# COMMUNITY DEVELOPMENT DEPARTMENT

SUBJECT: H-2021-0072

Settlers Square MDA

Modification to the existing Development Agreement (Inst. #2016-097989) for the purpose of replacing the previous agreement with a new one to incorporate a new concept plan consisting of commercial and residential uses.

EXHIBIT B
Conceptual Site Plan

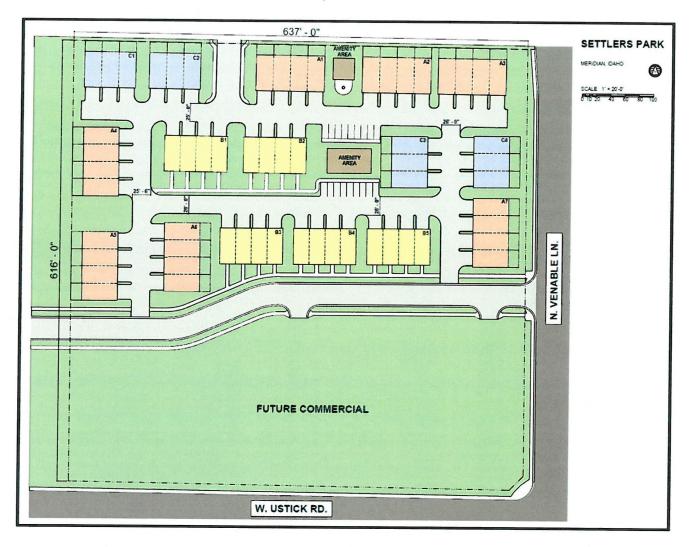
Although the proposed development would be a new type of residential in this area (townhome style instead of traditional garden style walk-up apartments), the submitted concept plan lacks many of the design concepts shown and outlined in the comprehensive plan for mixed-use areas. In general, the future commercial area is being reduced while increasing the residential area and its impact in this area of the City with little to no neighborhood serving commercial uses. At a minimum, the following mixed-use policies are not met with the proposed plan whereas the existing one does comply:

• Mixed use areas should be centered around spaces that are well-designed public and quasipublic centers of activity. Spaces should be activated and incorporate permanent design elements and amenities that foster a wide variety of interests ranging from leisure to play. These areas should be thoughtfully integrated into the development and further placemaking opportunities considered. Staff does not find the proposed concept plan meets this policy as no integration of the residential and commercial areas are shown; no placemaking or

- thoughtful integration of the mix of uses is present in the proposed concept plan especially when compared to the existing commercial concept plan.
- Supportive and proportional public and/or quasi-public spaces and places including but not limited to parks, plazas, outdoor gathering areas, open space, libraries, and schools that comprise a minimum of 5% of the development area are required. Outdoor seating areas at restaurants do not count towards this requirement. Based on the submitted concept plan, there are not enough details to show compliance with this plan. The proposed multi-family residential area appears to be isolated and no shared areas are shown, as noted in this policy.

- All mixed use projects should be accessible to adjacent neighborhoods by both vehicles and pedestrians. Pedestrian circulation should be convenient and interconnect different land use types. Vehicle connectivity should not rely on arterial streets for neighborhood access. Although the proposed concept plan does not require arterial streets for neighborhood access, the plan would force residents from the north to drive through the multi-family development to get to the commercial which could force them to utilize Venable for ease of access, further reducing accessibility for this mixed use area. Furthermore, there are minimal pedestrian facilities shown on the proposed plan to connect the existing residential and the proposed residential to the commercial along Ustick; it appears the intent is for residents to use the multi-family drive aisles which does not provide adequate pedestrian safety.

- A mixed use project should include at least three types of land uses. Exceptions may be granted for smaller sites on a case-by-case basis. This land use is not intended for high density residential development alone. As noted, not each mixed-use project is intended to provide at least three types of land uses. However, with the existing and approved development in this MU-C area, a vast majority of the area will be medium and high-density residential which is not a desired outcome. Staff finds reducing the last remaining area of undeveloped commercial area to incorporate more residential is in direct contradiction to this policy.

Overall, Staff is concerned the proposed plan is more residentially focused, lacks integration with the commercial area, and does not comply with the mixed-use policies in the comprehensive plan. For the reasons and concerns noted, Staff is not supportive of the proposed DA modification and has recommended denial of the request.

Staff recommends denial of the modification to the DA as proposed by the Applicant and finds the existing concept plan and DA provisions are better suited to address development of the subject property.
